Intel[®] Xeon[®] Processor 7100 Series

Specification Update

| *May 2009*

Order Number: 314554-005

Figure 4-5. Processor Bottom-Side Markings

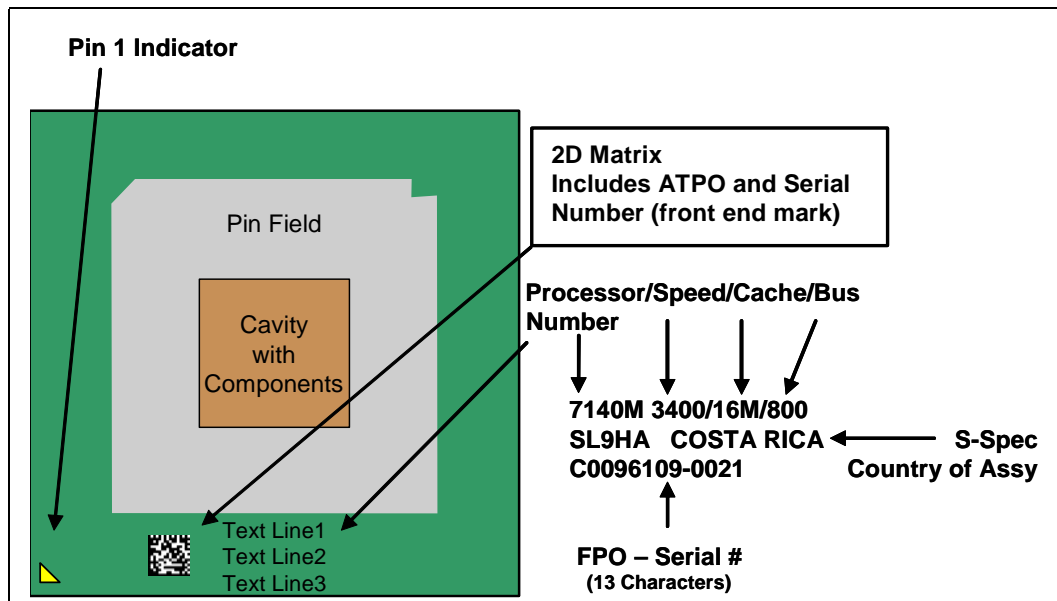
1. 2D Matrix Added to the Bottom Side Laser Mark

Figure 4-5. Processor Bottom-Side Markings has been updated to include a 2D Matrix.
